City of Dublin

Re: Final Plat – Lowell Trace, Section 2, Lots 62, 63, and 64

REPLAT OF THE REAR NO BUILD ZONE SETBACK LINE FOR LOTS 62, 63, & 64 LOWELL TRACE SECTION 2 (P.B. 69, PG. 5)

Details	**Amended Final Development Plan**

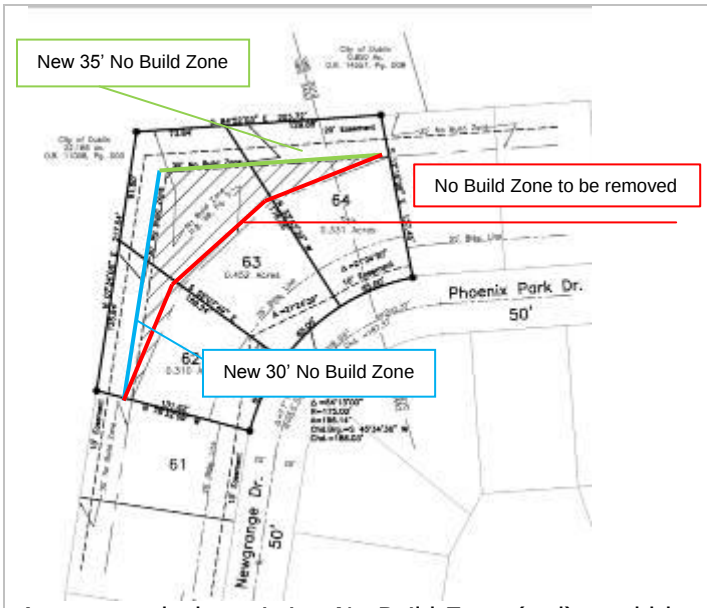
As proposed, the existing No Build Zone (red) would be removed and the 30-foot No Build Zone (blue) along the western boundary and the 35-foot No Build Zone (green) along the northern boundary would meet.
Text Modification	Exhibit "D" in the approved development text requires No Build Zones no greater than 100 feet from the right-of-way and, as proposed, the revised No Build Zones will be between 110 and 175 feet from the right-of-way, requiring a minor modification to the development text.

Proposed Plat

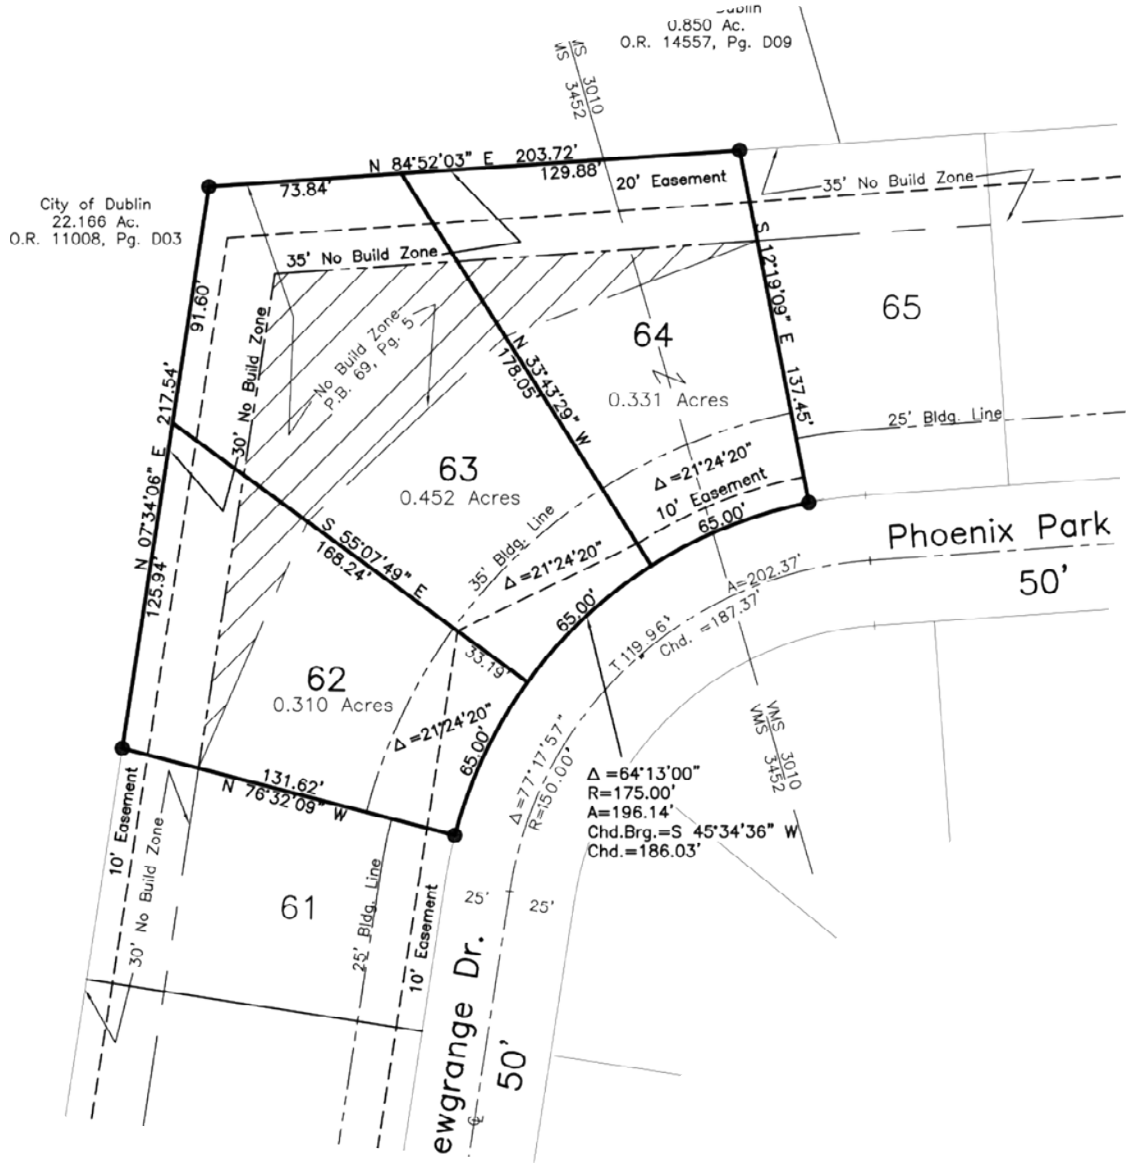
Mr. Cline said the proposed revised text also states that this is to revise and remove this area and so now, there will be a new NBZ which is the blue area shown on the amended final plat.

Mr. Hardt said that the text stated the NBZ was to be terminated, but that was not noted on the revised final plat.
